REQUEST FOR INFORMATION **DATE:** May 05, 2016 **NO.:** RFI-064

Project Name: Webster University Interdisciplinary Science Building Project No.: 15051

Subject: Pilaster baseplate/foundation wall and retrofit waterstop

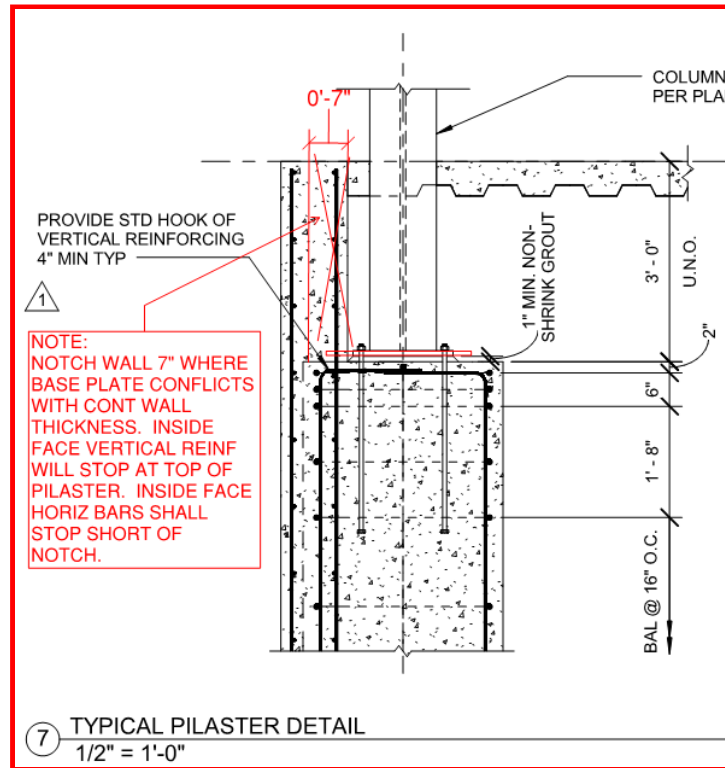
1. Please see the attached Spreadsheet referencing the concrete foundation pilasters. Upon reviewing each typical baseplate detail and dimensions at each pilaster, the highlighted cells with red text in the attached spreadsheet depict instances where baseplates overlaps into the foundation walls. The typical pilaster detail 7/S0504 does not appear to hold true at these identified locations. Please review and advise on the issue encountered.

1. SEE SKETCH

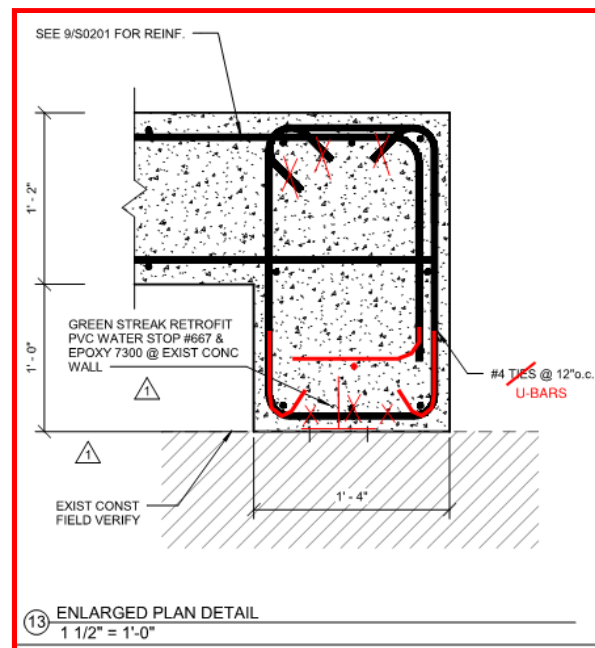
3. Contract drawing detail 13/S0201 illustrates the placement of Retrofit PVC Waterstop at connections to existing concrete. The detail shows "#4 TIES @ 12" o.c." which will conflict with the 6-3/8" waterstop leg. Please advise on how to install the Retrofit PVC Waterstop without conflicting with reinforcing ties.
RECOMMENDATION: Relocate the Retrofit PVC Waterstop to either side of the ties and extend the 1'-4" Concrete dimension in the same direction.

3. SEE SKETCH
